Re: Alaska Railroad Corporation, Anchorage Terminal Reserve RI/FS
Administrative Order on Consent EPA Docket No. CERCLA-10-2004-0065
Remedial Investigation/Feasibility Study Work Plan, Revision 1

***Review of Remedial Investigation/Feasibility Study Work Plan, Alaska Railroad Corporation, Anchorage Terminal Reserve
(Prepared by RETEC, June 23, 2005)***

**Remedial Investigation / Feasibility
Study Work Plan
Revision 1
Volume 1 of 2**

**Alaska Railroad Corporation
Anchorage Terminal Reserve
U.S. EPA Docket No. CERCLA 10-2004-0065**

Figure 2-3b Travel Time through the Bootlegger Cove Formation

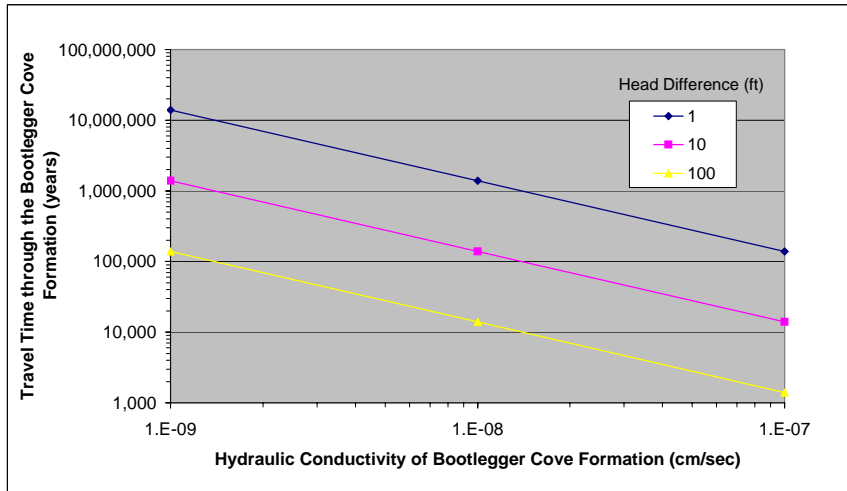
Example 1 The first example calculation was performed to assess how long it would take contaminants to travel from the shallow aquifer to the deep aquifer through the Bootlegger Cove Formation. The input values and results of the example calculations are shown in Figure 2-3b. The calculations assume the Bootlegger Cove is greater than 120 feet thick at the rail yard location (Updike and Carpenter, 1986) and that the hydraulic conductivity of the Bootlegger Cove formation is in the

range of 10^{-7} to 10^{-11} cm/sec (estimated values for marine silts and clays from Freeze and Cherry, 1979). The graph in Figure 2-3b plots groundwater travel time (y-axis) as a function of hydraulic conductivity of the Bootlegger Cove Formation (x-axis) and head difference between the deep and shallow aquifers. Head difference values of 1, 10 and 100 feet are plotted on the figure. Head difference values on the order of 100 feet may be expected near a pumping well, while head difference values between 10 feet and 1 foot could be expected at greater distances from the pumping well. Given that 1) the closest AWWU wells are approximately 0.5 miles from the Site, 2) groundwater pumping from the deep aquifer at high production rates is very unlikely within the Site, and 3) the largest differences in hydraulic head are localized near the pumping wells, the travel times within the 10-foot and 1-foot head difference lines are more relevant to the travel times the AWWU pumping would induce at the Site. As shown on Figure 2-3b, given a hydraulic conductivity of 10^{-7} cm/sec and a head difference of 10 feet it would take contaminants about 10,000 years to travel from the shallow aquifer to the deep aquifer through the Bootlegger Cove formation. These calculations assume that high pumping rates from the deep aquifer would be sustained for the duration of the travel time (10,000 years) and do not include the effects of retardation or biodegradation, which would tend to delay the arrival of the contaminant in the deeper aquifer and reduce the long term contaminant concentration in the deep aquifer. This calculation demonstrates that given a downward gradient during active pumping of the deep aquifer, the Bootlegger Cove formation would protect the water quality in the deep aquifer for the indefinite future and thus protect human health via the deeper aquifer groundwater ingestion route.
